10.4 Other Features of Steam and Power Conversion

The information in this section of the reference ABWR DCD, including all subsections, tables, and figures is incorporated by reference with the following departures and supplements.

Figure 10.4-6 Feedwater System

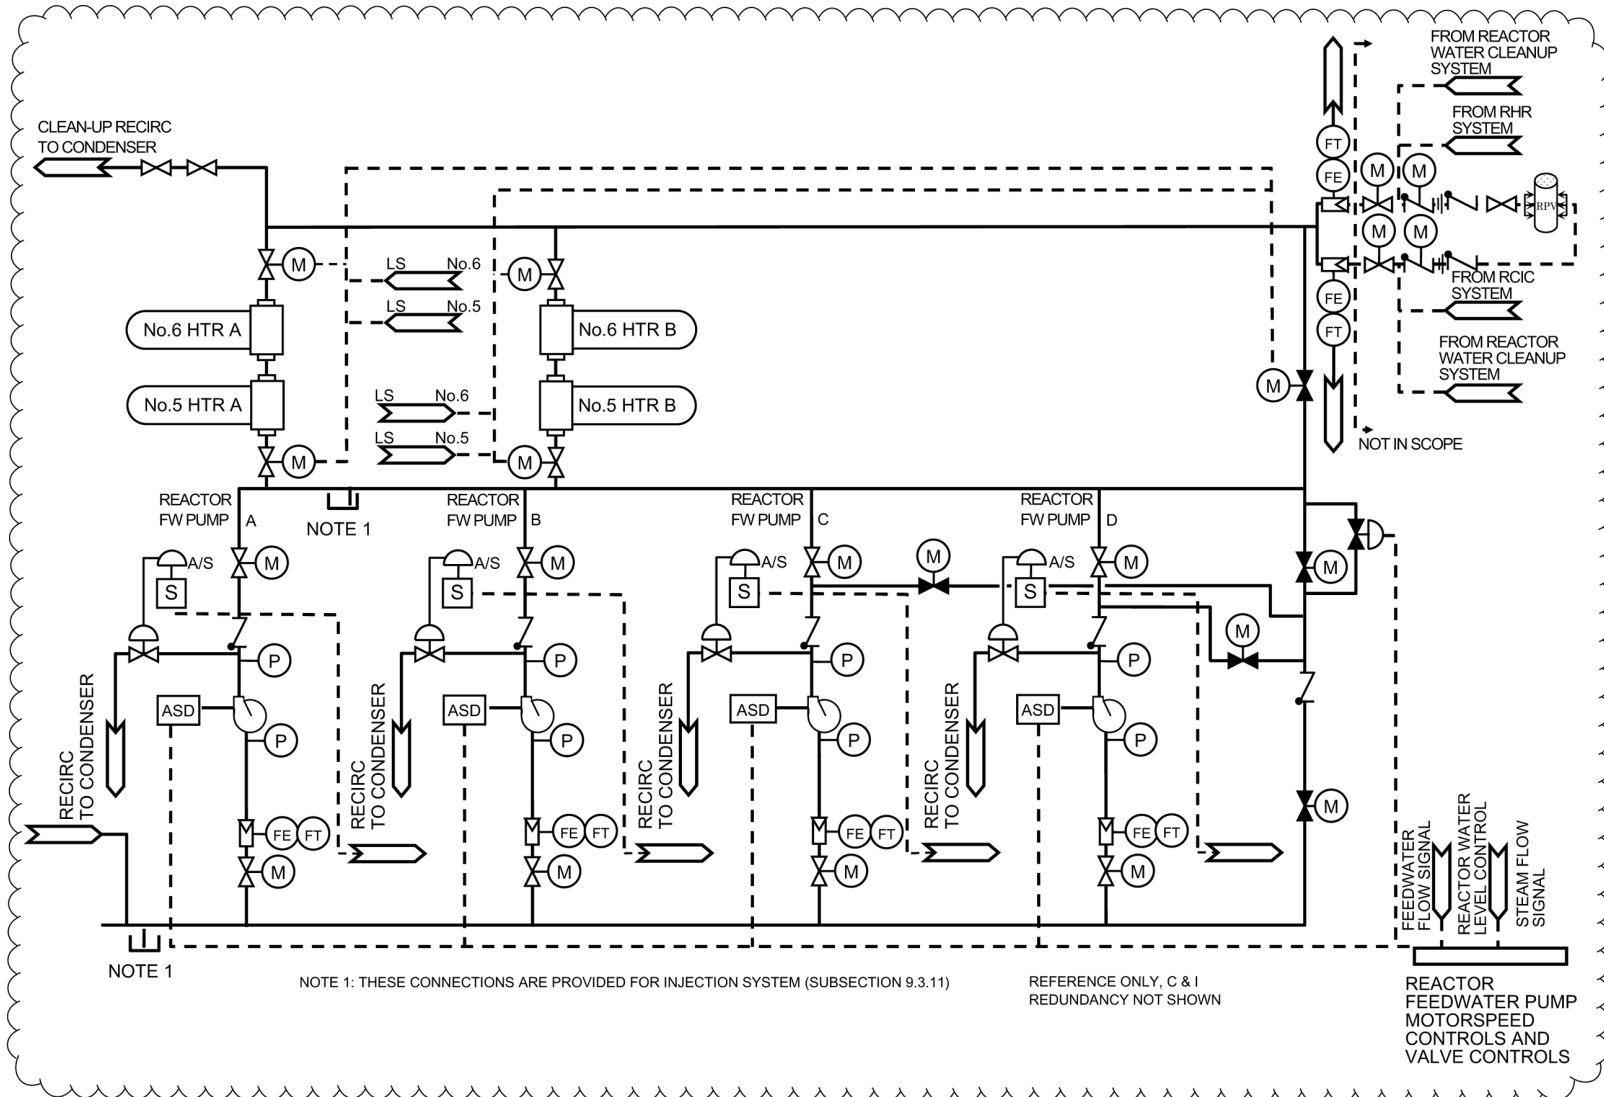
STD DEP 10.4-5 (Tables 10.4-4, 10.4-5 and 10.4-6, Figures 10.4-5, 10.4-6, 10.4-7, and 10.4-8)

The Condensate and Feedwater System (Figures 10.4-5 and 10.4-6) consists of the piping, valves, pumps, heat exchangers, controls and instrumentation, and the associated equipment and subsystems which supply the reactor with heated feedwater in a closed steam cycle utilizing regenerative feedwater heating. The system described in this subsection extends from the main condenser outlet to (but not including) the seismic interface restraint outside of containment. The remainder of the system, extending from the restraint to the reactor, is described in Chapter 5. Turbine cycle steam is utilized for a total of six stages of closed feedwater heating. The drains from each stage of the low-pressure feedwater heaters are cascaded through successively lower pressure feedwater heaters except the lowest and second lowest pressure feedwater heaters which drain to the low pressure heater drain tanks for each string. The drains from each low pressure heater drain tank flow into the external drain coolers of each lowest pressure feedwater heater and finally to the main condenser. The high pressure heater drains are pumped backward to the reactor feedwater pumps suction. The cycle extraction steam, drains and vents systems are illustrated in Figures 10.4-7 and 10.4-8.

Figure 10.4-9 Bypass Valve Control, Electro-Hydraulic Control Unit

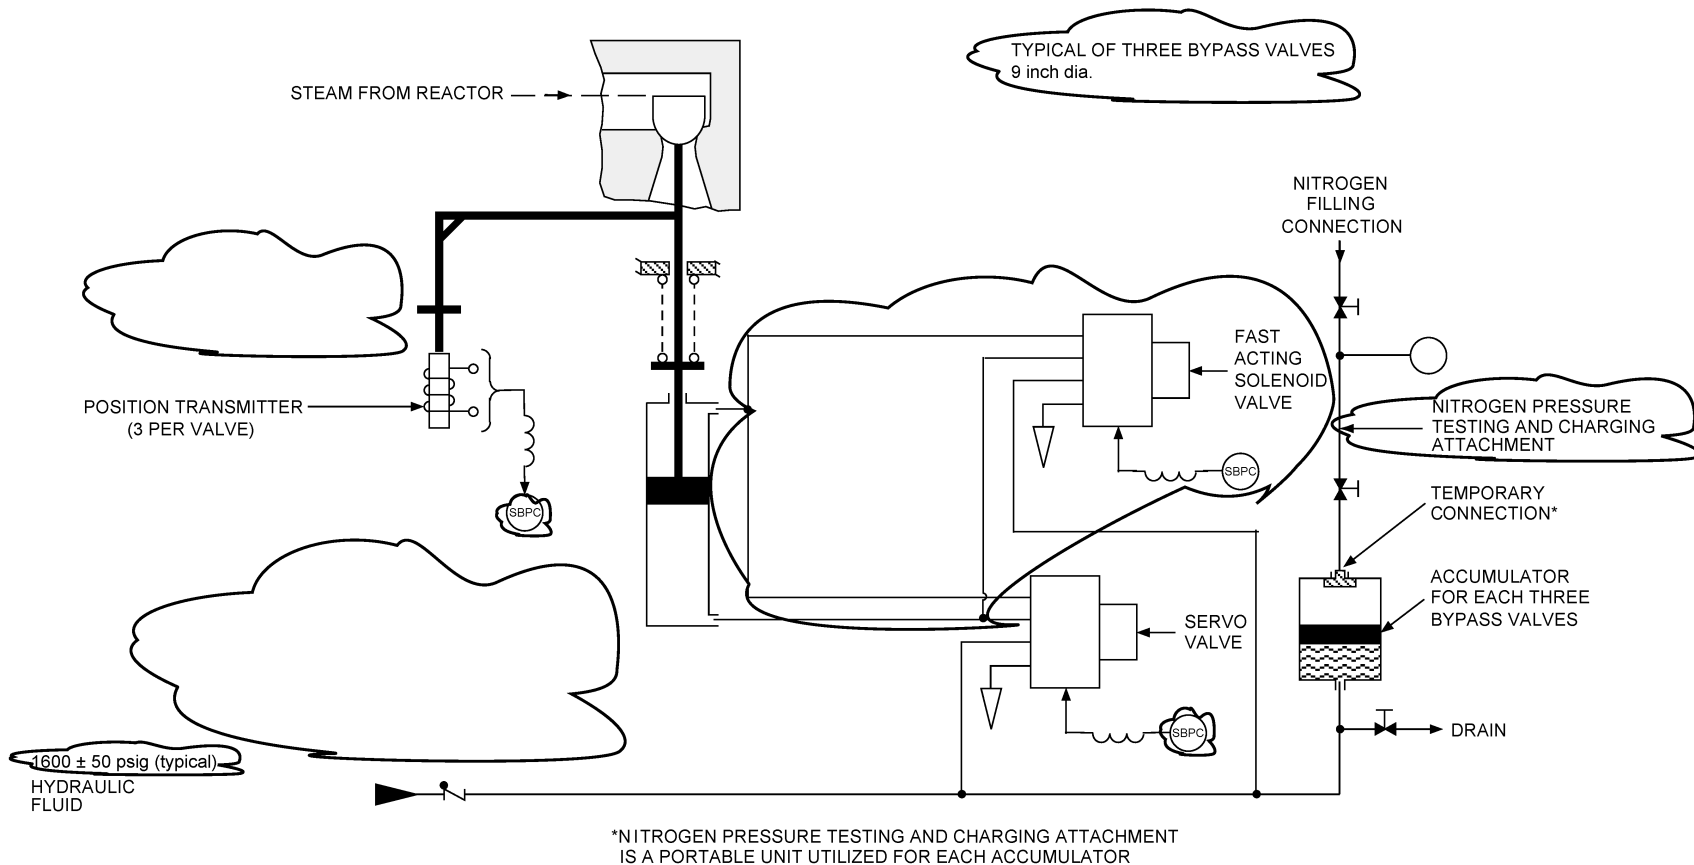
STD DEP 10.4-7 (Figure 10.4-9)
